ADDENDUM NO. 3

MAMMOTH YOSEMITE AIRPORT MAMMOTH LAKES, MONO COUNTY, CALIFORNIA

MULTIPURPOSE BUILDING –PHASE 2 AIP NO. 3-06-0146-____-2026

This Addendum No. 3 includes the following:

Drawing No.
M03-001A

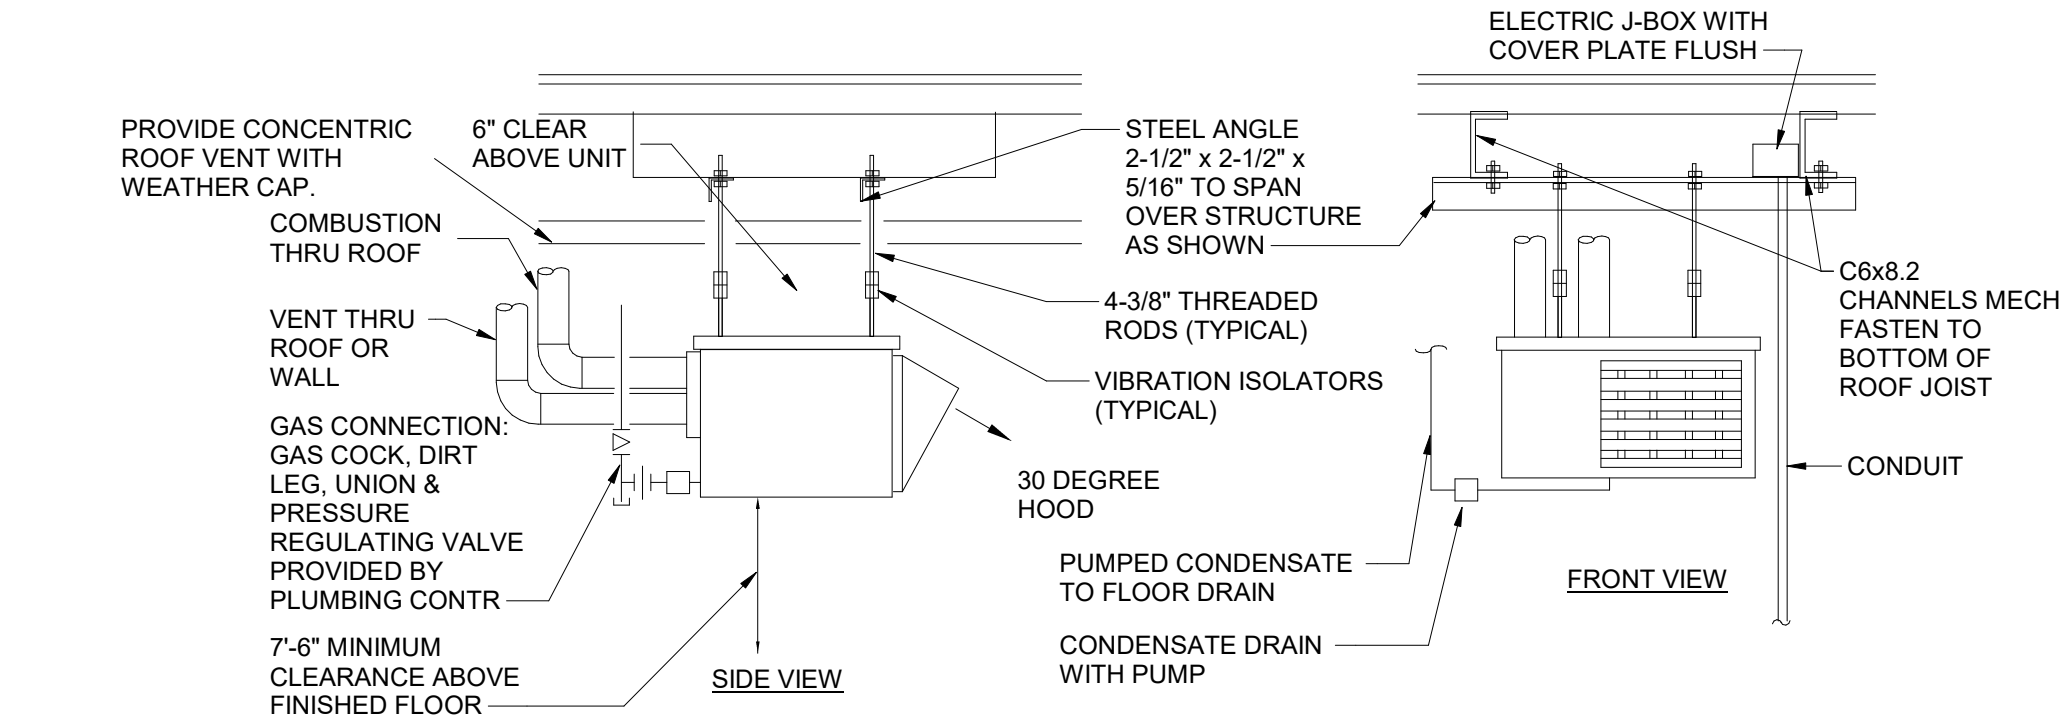
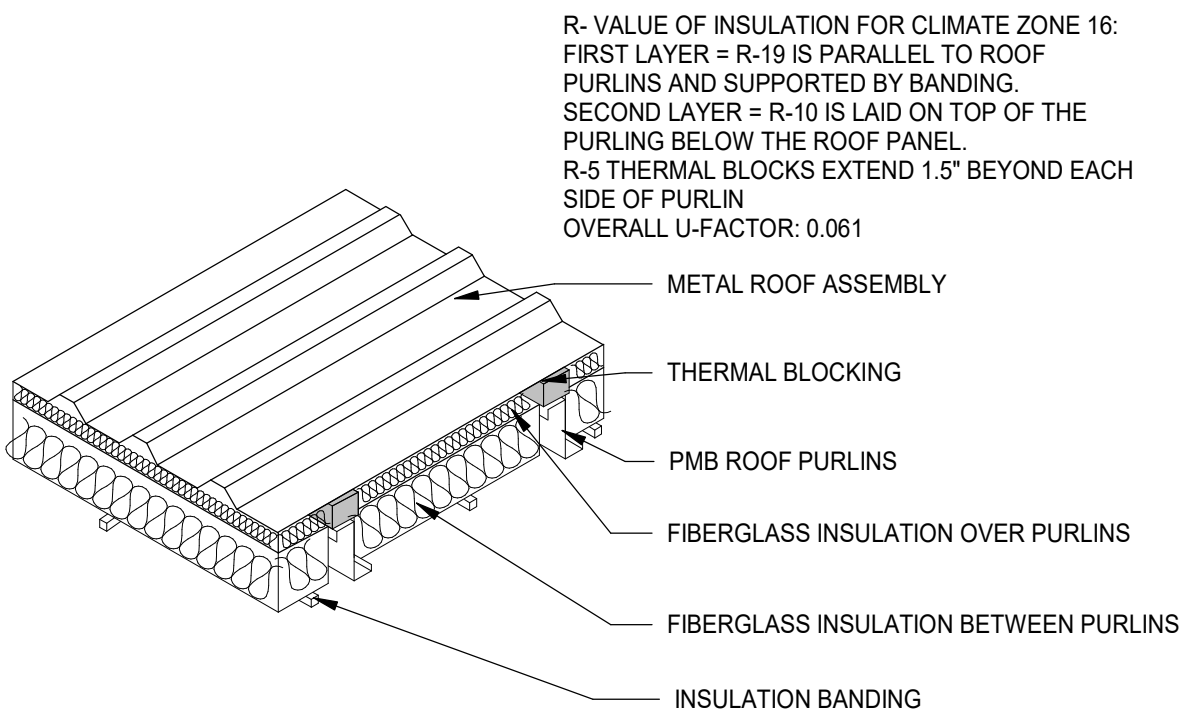
Item 3-5 *Sheet No. M03-001A*

Delete Sheet No. M03-001A

Replace with attached Sheet No. SM03-001A, Addendum No. 3 – Revised Vehicle Exhaust Schedules

6 FALL PROTECTION TIE OFF ASSEMBLY
SCALE: 1" = 1'-0"

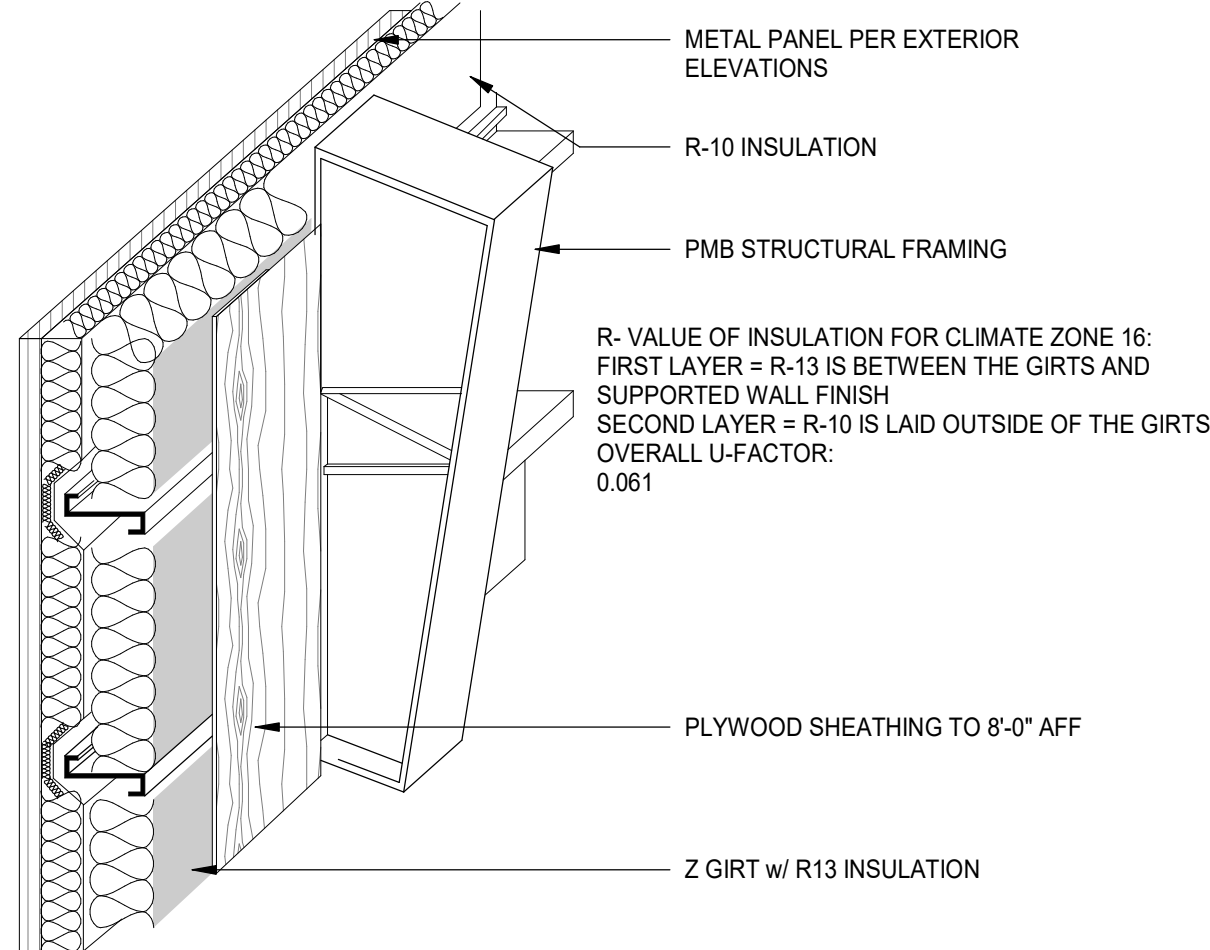
Item 3-4 *Sheet No. A50-03*

Delete Sheet No. A50-03

Replace with attached Sheet No. A50-03, Addendum No. 3 – Revised fall protection and metal canopy detail
